From: Ken Bird
To: [Butler, Elizabeth](#)
Cc: [Tom Ebbert \(ebbert@ppg.com\)](#); [Feinberg, Richard \[C\]](#); [Brad Zewe](#)
Subject: Riverside Industrial Park Superfund Site- Phase 1 Field Modifications
Date: Tuesday, December 05, 2017 10:17:46 AM
Attachments: [Riverside - Sample Location South.pdf](#)
[Riverside - Sample Location North.pdf](#)
[2017.12.04 Field Modifications Memo.pdf](#)
[2017-09-01 CLP MA \(ISM02.4\) ICPMS Soil+AlCaFeMgKNa r1.docx](#)

TO: Elizabeth Butler - USEPA
FROM: Woodard & Curran on behalf of PPG
DATE: December 4, 2017
RE: Modifications to the Riverside Industrial Park Superfund Site Work Plan

**MONITORING WELL / SOIL BORING
/ SAMPLE LOCATION MAP SOUTH**

RIVERSIDE INDUSTRIAL PARK
SUPERFUND SITE
EPA ID: NUSR00204232
TAX BLOCK 614

FIGURE 6-2

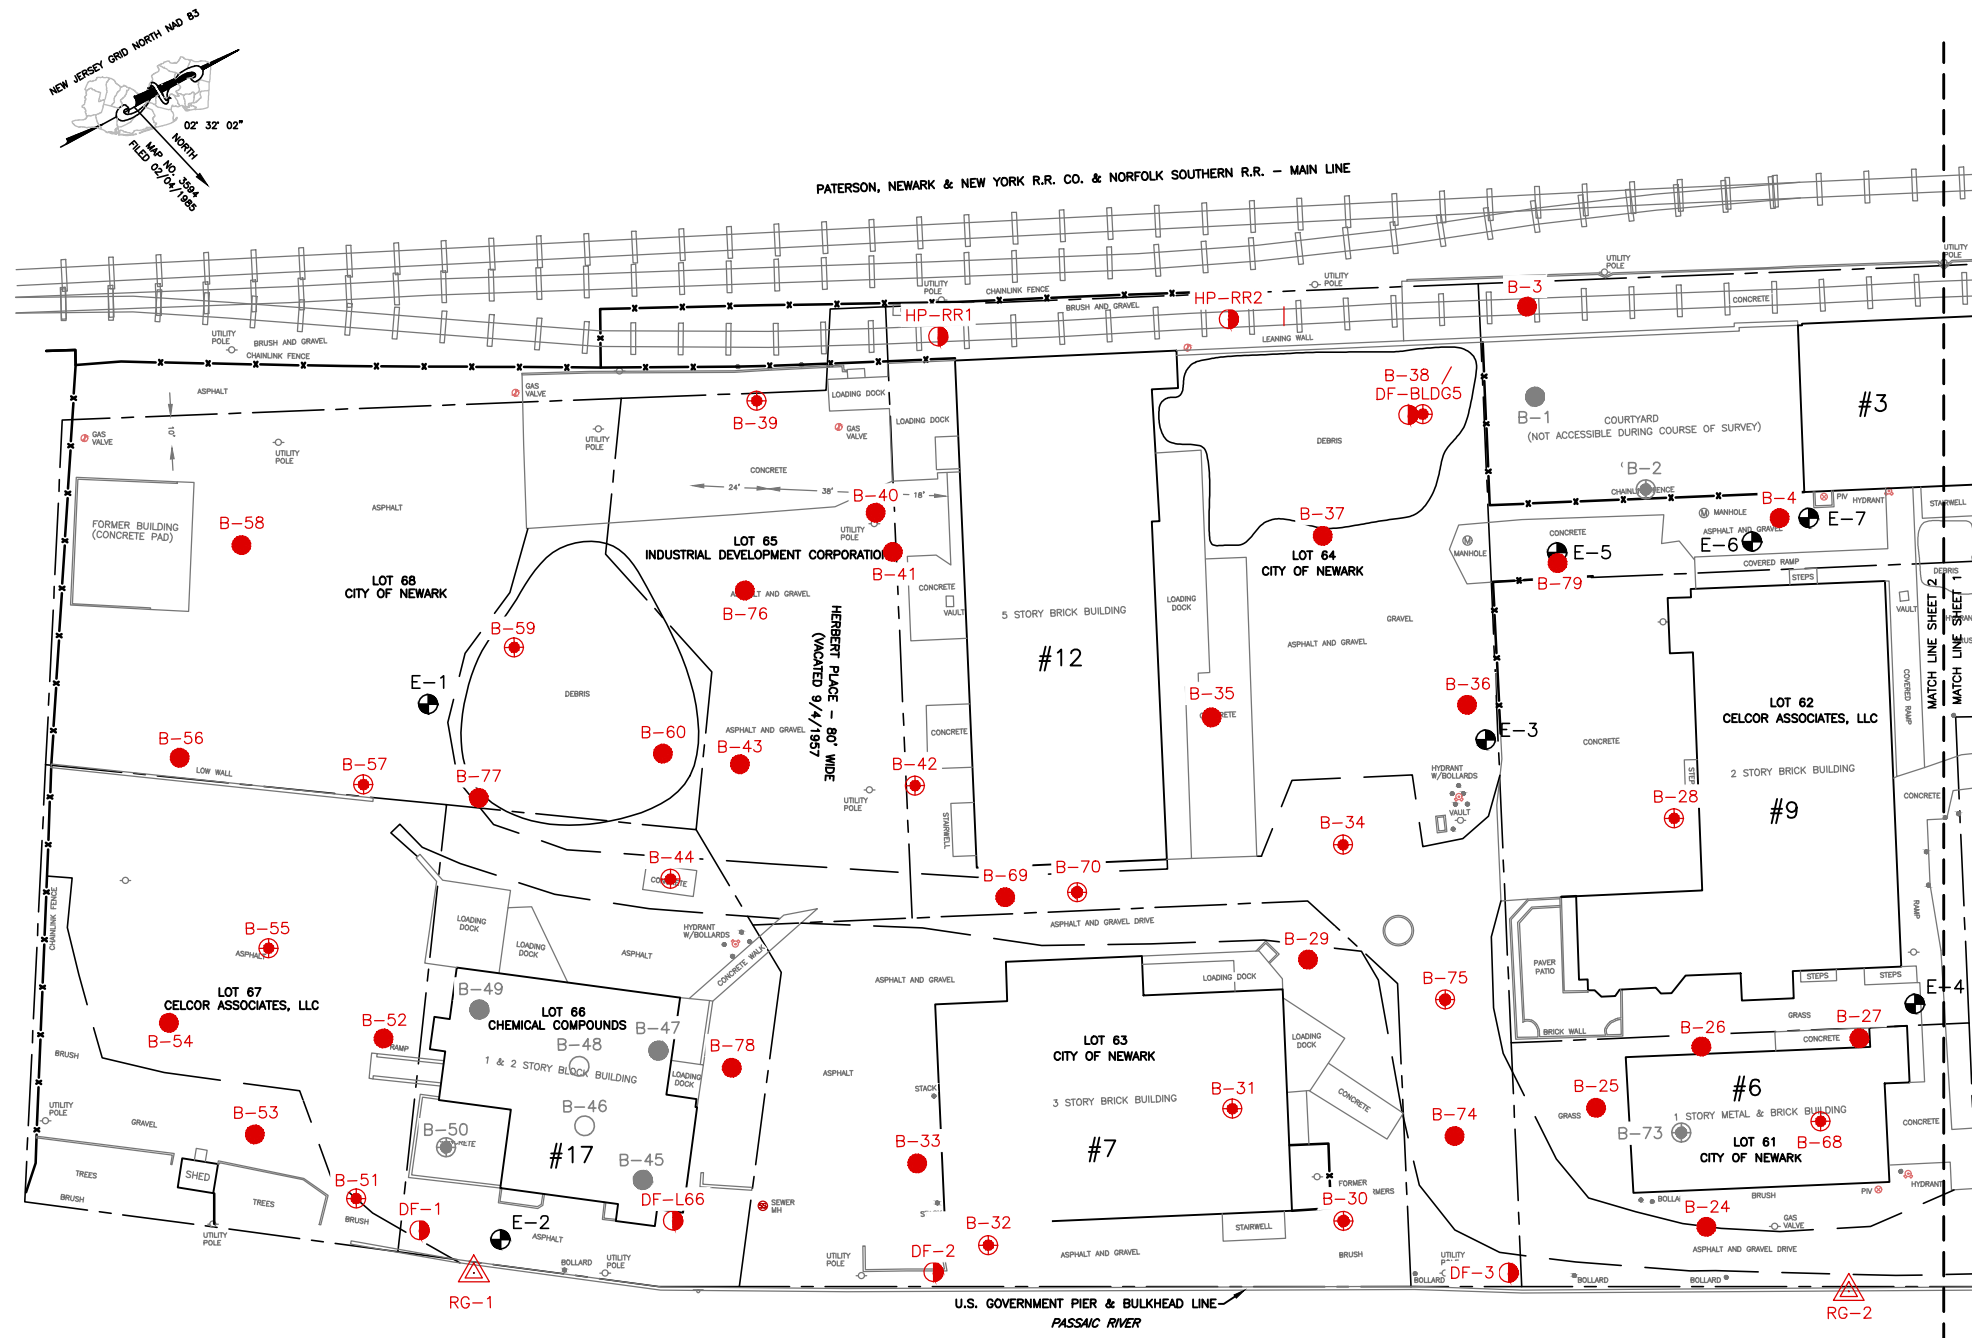
- NOTE:
1. BORING B-11 WAS CONVERTED TO A TEMPORARY WELL POINT LOCATION; NO SOIL SAMPLE COLLECTED DUE TO SATURATION.
 2. ON BORINGS B-10, B-68 & B-71 ONLY ONE SOIL SAMPLING INTERVAL WAS COLLECTED. THE SECOND SOIL SAMPLING INTERVAL ENCOUNTERED REFUSAL OR SOIL SATURATION
 3. BORINGS B-78 AND B-79, TEMPORARY WELL POINTS B-30, B-70, AND B-75 ADDED TO WORK PLAN SCOPE WITH EPA CONSULTATION
 4. TEMPORARY WELL POINTS B-9 REPLACED B-71, B-20 REPLACED B-72, B-51 REPLACED B-50, AND B-68 REPLACED B-73 WITH EPA CONSULTATION.

- BORING B-11 WAS CONVERTED TO A TEMPORARY WELL POINT LOCATION; NO SOIL SAMPLE COLLECTED DUE TO SATURATION.
- ON BORINGS B-10, B-68 & B-71 ONLY ONE SOIL SAMPLING INTERVAL WAS COLLECTED. THE SECOND SOIL SAMPLING INTERVAL ENCOUNTERED REFUSAL OR SOIL SATURATION
- BORINGS B-78 AND B-79, TEMPORARY WELL POINTS B-30, B-70, AND B-75 ADDED TO WORK PLAN SCOPE WITH EPA CONSULTATION
- TEMPORARY WELL POINTS B-9 REPLACED B-71, B-20 REPLACED B-72, B-51 REPLACED B-50, AND B-68 REPLACED B-73 WITH EPA CONSULTATION.

1	ADD BLD NUMBERS AND BORINGS	4/8/17
2	ADJUST LOCATIONS - FIELD CHANGES	11/1/17
REV	DESCRIPTION	DATE
DESIGNED BY: ---	CHECKED BY: B.T.Z.	
DRAWN BY: D.I.M.	13620.D1-2.dwg
